Re: Site Specific Investigation  
Upland Heights B4  
Technical Review

This letter serves to present the findings of our technical review of the site specific investigation prepared by WWC Engineering (WWC) and presented to City of Laramie for the future development of the Upland Heights B4 Lot located within the Casper Aquifer Protection Area. Our review comments will be presented to address the adequacy of this site specific investigation in fulfilling the requirements of the City of Laramie's Unified Development Code, subsection 15.08.040.A.8.

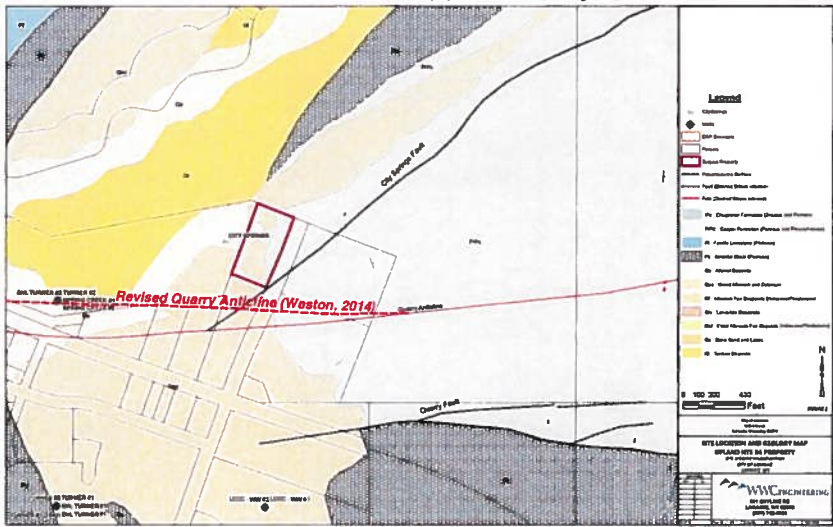
WWC identified three structural features near Upland Heights B4 Lot – two faults (City Springs and Quarry Faults) and a structural fold (Quarry Anticline). The Quarry Fault is well outside of the required vulnerable feature setback distance of 100 feet (City of Laramie Unified Development Code, subsection 15.08.040.A.7(b)). WWC has indicated that the City Springs fault is approximately 10 feet southeast of the property boundary. The third feature – the hinge axis of the Quarry Anticline is shown by WWC to be approximately 250 south of Lot B4. However, based on field work performed by Weston Engineering (Weston), Weston proposed that the fold axis of the Quarry Anticline may actually be located further to the north than that mapped by Ver Ploeg (2009) as shown in the adjacent figure. However, this fold axis would still be beyond the 100 foot setback distance.

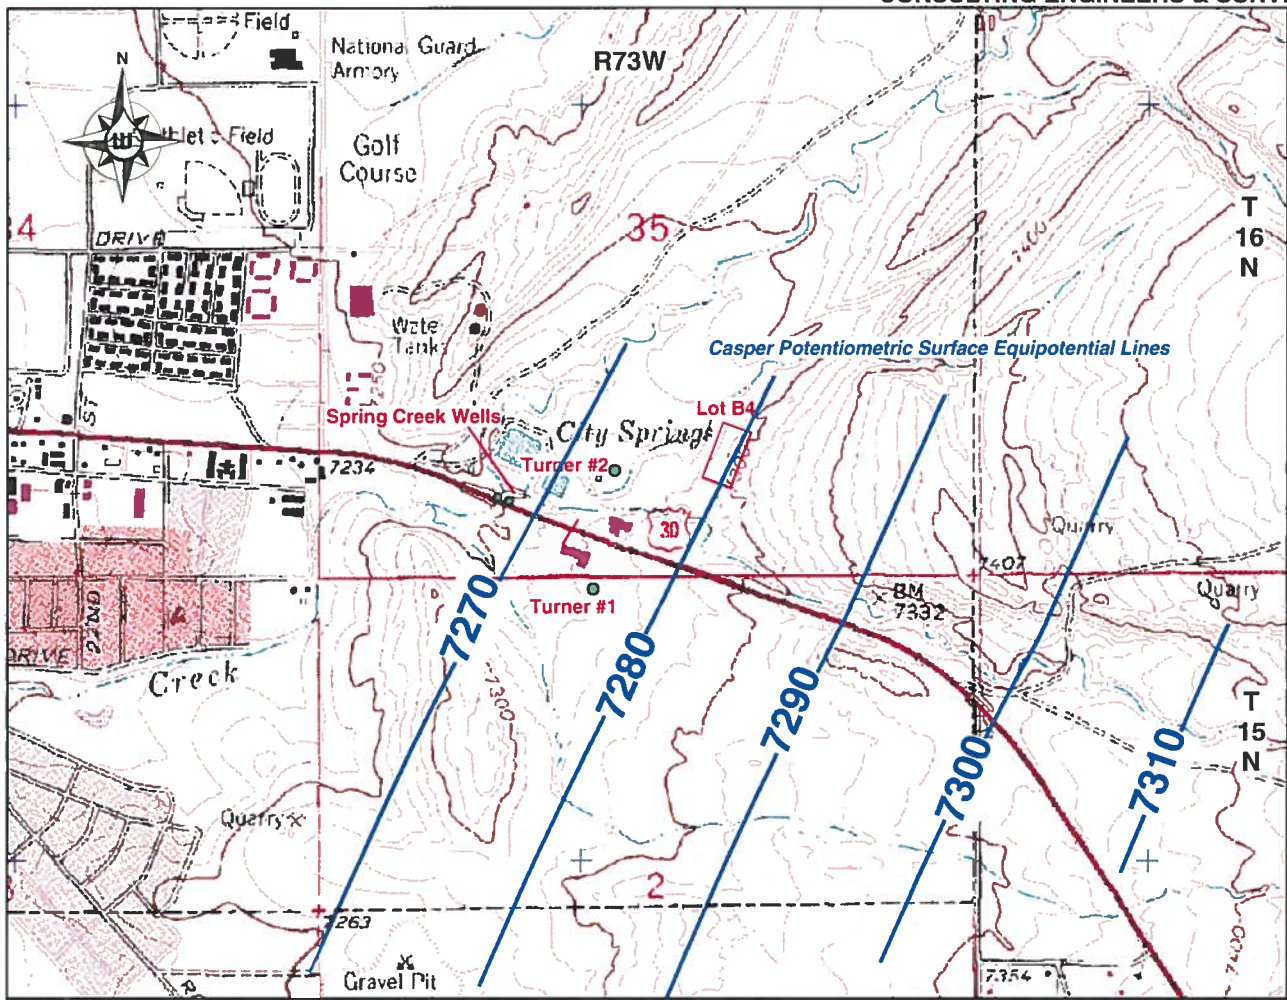
WWC's potentiometric surface map for the Casper Aquifer is very limited in data. There is only one equipotential line visible in the vey southeast corner of Figure 1 which shows the 7,300 foot equipotential line for the Casper Aquifer potentiometric surface. Their narrative is correct in that with a surface elevation of the subject property ranging from 7,308 feet to 7,312 feet that the depth to the Casper potentiometric surface is approximately 30 feet. The figure on the following page was developed by the author of this review from several previous studies in the area and it depicts the potentiometric surface a little more definitively than that shown by Figure 1 in WWC's SSI report.
